**Conditional Use Permit
Staff Report and Recommendation**
Community Development Department, Planning Division

LAND USE REQUEST: Planning Commission review and approval of a conditional use permit for a recreational cannabis dispensary

FILE NUMBER(S): 311-18-000017-PLNG

PROPERTY LOCATION: 3331 Pacific Avenue

Existing Pacific Avenue façade (above) & the proposed façade rendering (below)

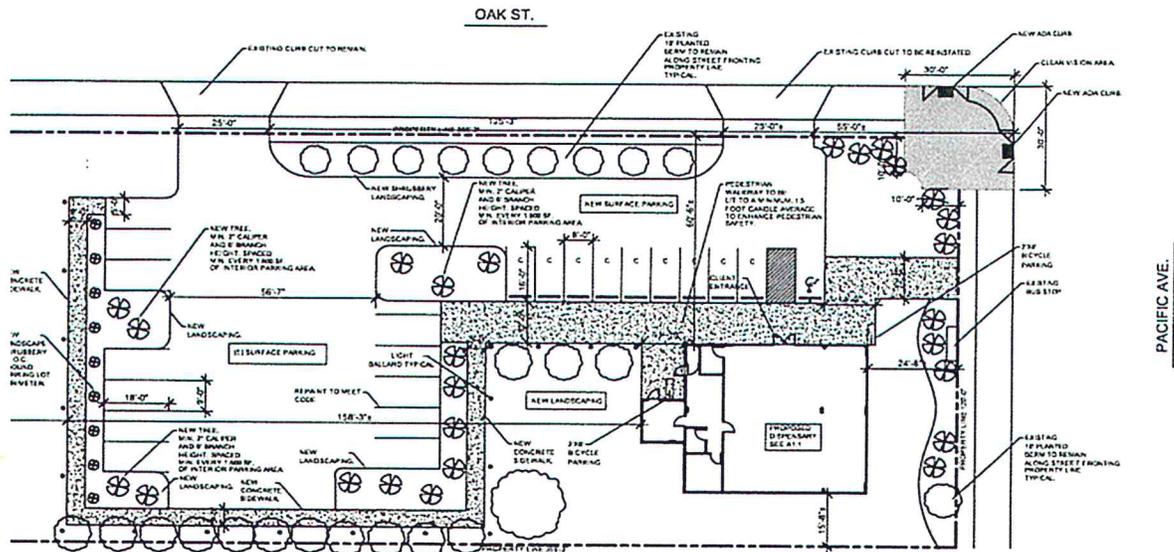
Finding: The building's façade is not adjacent to the sidewalk, but it is adjacent to the pedestrian walkway connecting the Pacific Avenue sidewalk to the car park. As such, an awning over at least the building entrance is required, and staff has recommended a **condition** of approval for that additional design element.

Finding: The existing building does not comply with these standards. The applicant proposes to install new storefront systems in both the Pacific Avenue and Oak Street facades with window openings that would equal or exceed 50% of the facades. The windows would not be treated to block views. These standards are met.

7. Off-street parking shall be reduced to 12 spaces, in compliance with DC §10.8.515 *Off-Street Parking Requirements*.
8. Install an awning over the building entrance in compliance with DC §10.8.710(B)(3)(b).

Pacific Avenue / Oak Street Intersection – Note Driveway Location

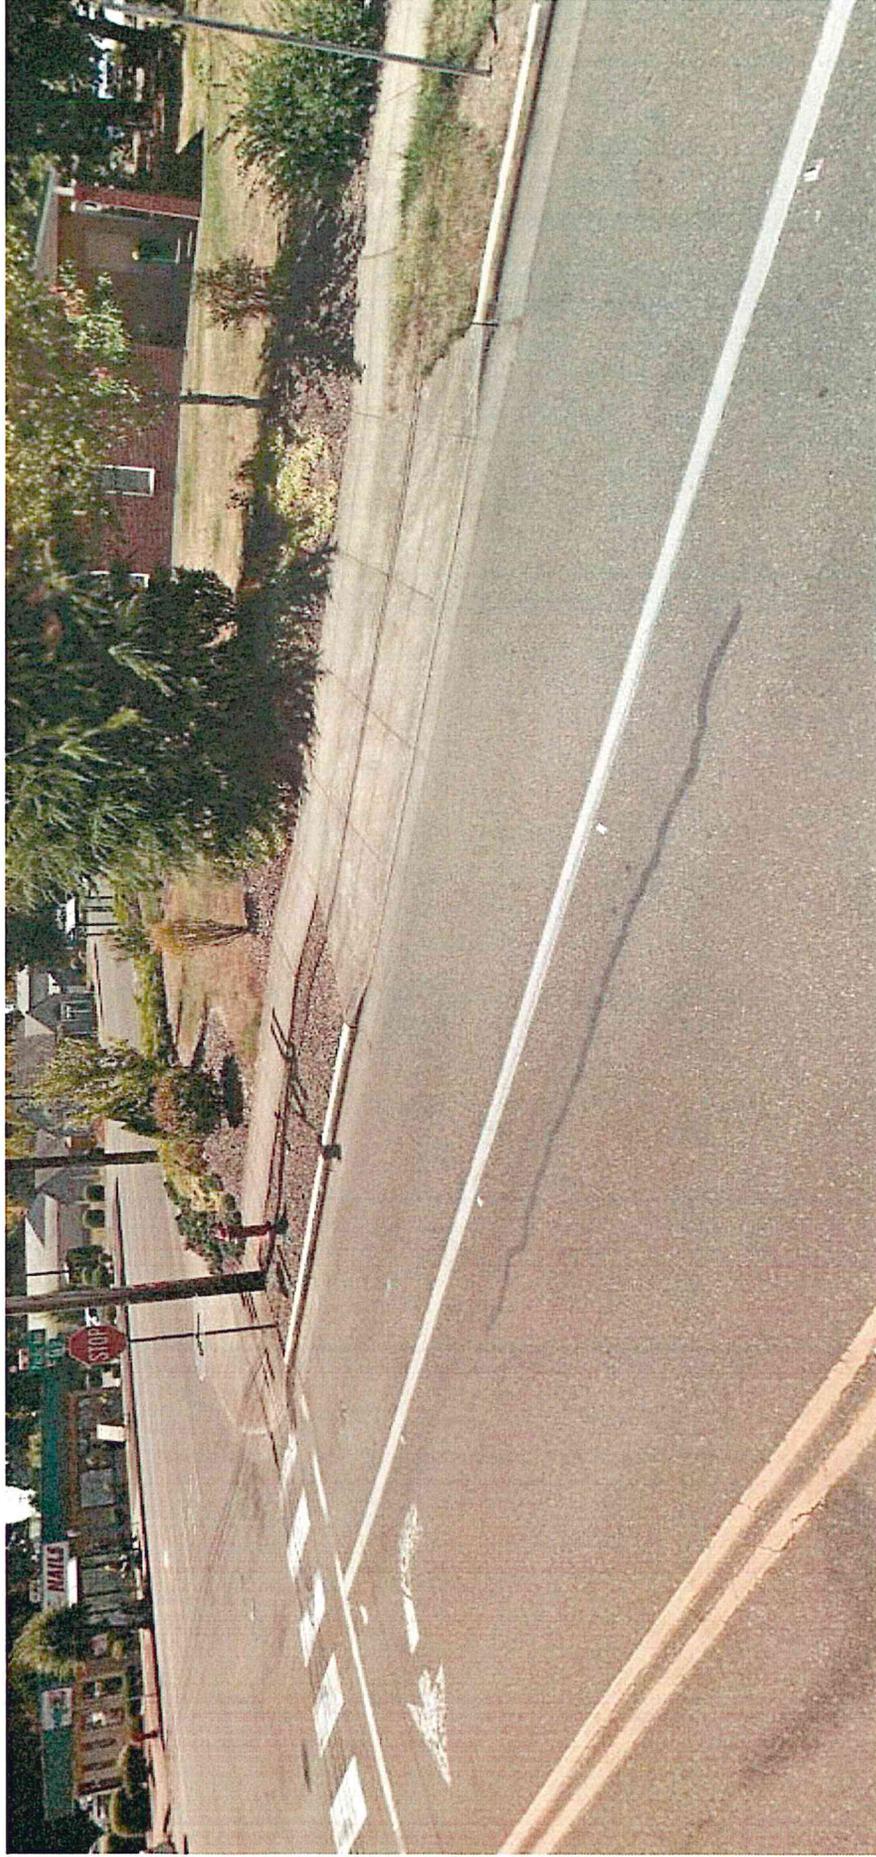
Two drive approaches have been installed along Oak Street, but only the northerly approach is used. The applicant proposes to also use the south drive approach, which has not been active for more than 28 years (see images below). This driveway would be located about 25 feet from the Pacific Avenue right-of-way.

As noted above, Oak Street is a designated Collector street. DC §10.8.130(C)(3) stipulates that "No portion of a curb cut shall be located closer to an intersecting street right-of-way line than 50 feet on a collector street."

Absent a variance application, staff is recommending a **condition** that the existing south drive approach be removed and the parkway restored, as required by Forest Grove Code (FGC) §151.068 *Discontinuance of Driveway Use*. This section notes that “*When a property has a driveway that is discontinued or abandoned or the use of the property changes, the curb line shall be made to conform to applicable driveway provisions of the city within 60 days after discontinuance of the driveway use.*”

Oblique Site View

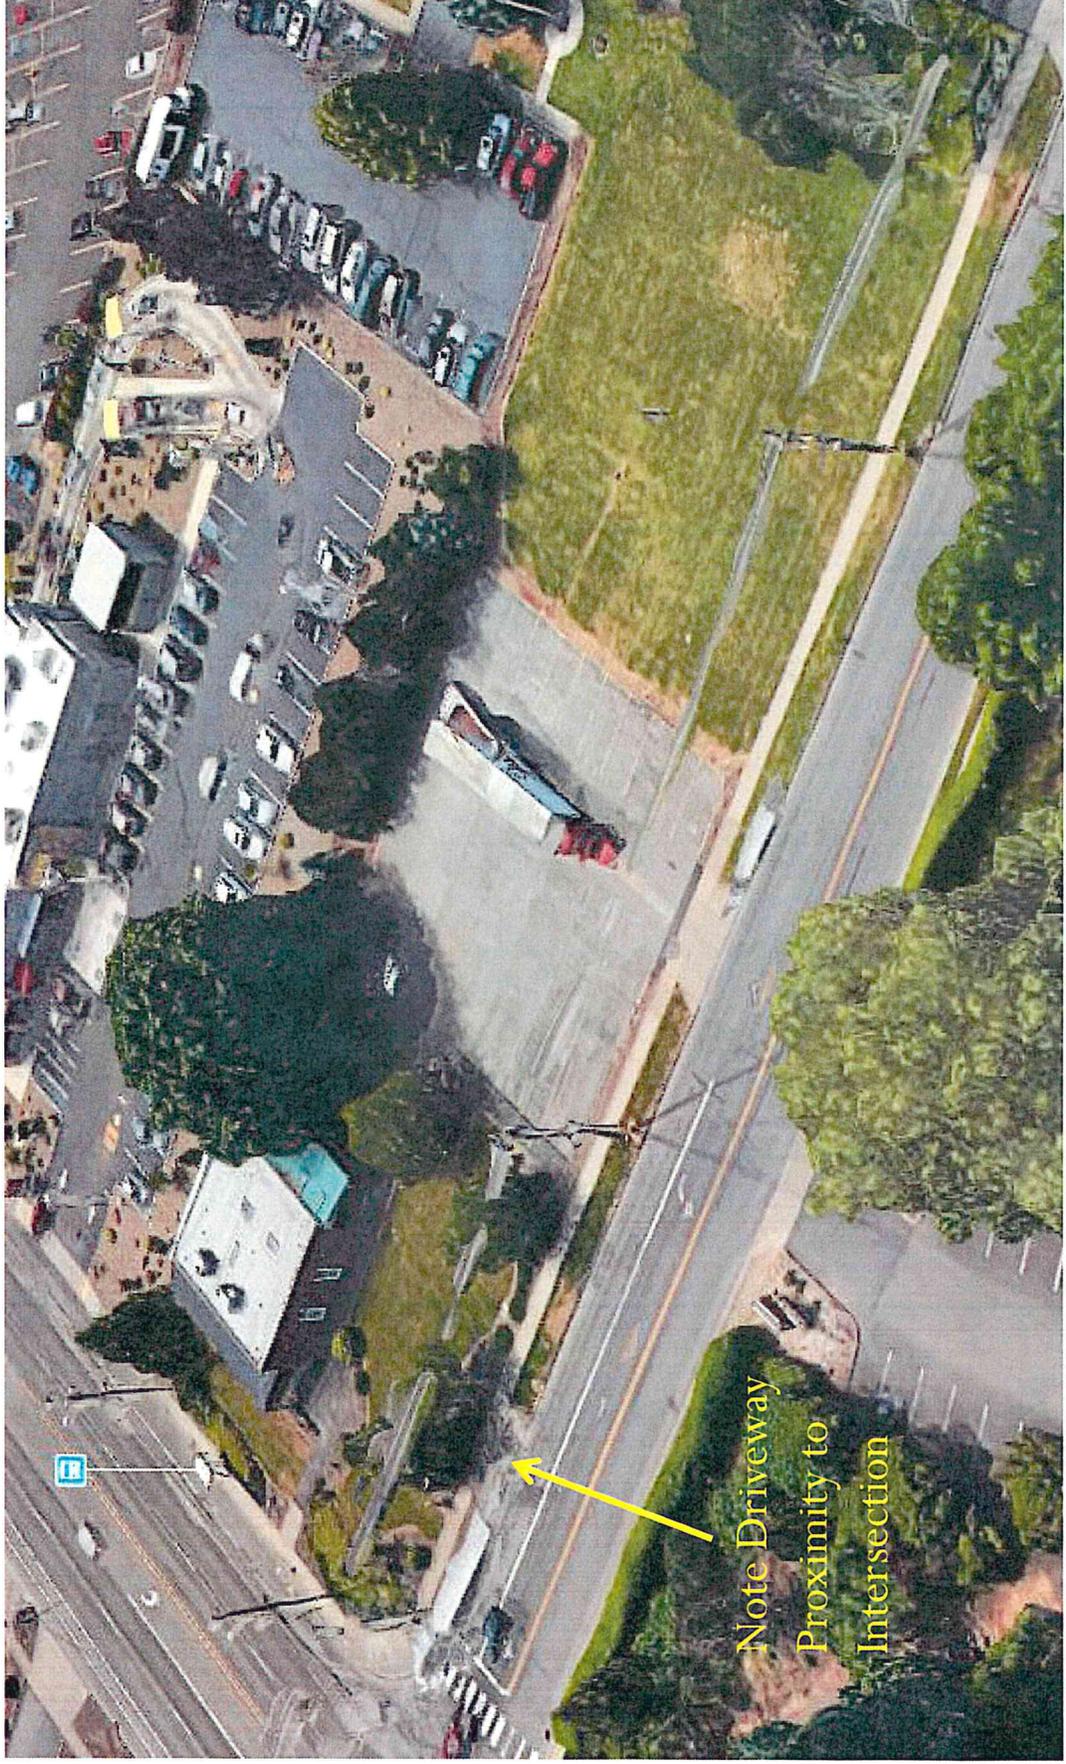
Because the south driveway would be less than 50 feet from the Pacific Avenue right-of-way, activating its use would require Planning Commission approval of a variance. If the applicant wishes to apply for a variance, then this hearing will need to be continued to consider that application in conjunction with the site and design review process. If a variance request is filed, it would also need to include a traffic study to address the ODOT and AASHTO standards noted by the Engineering Department above.

Note Driveway
Proximity to
Intersection
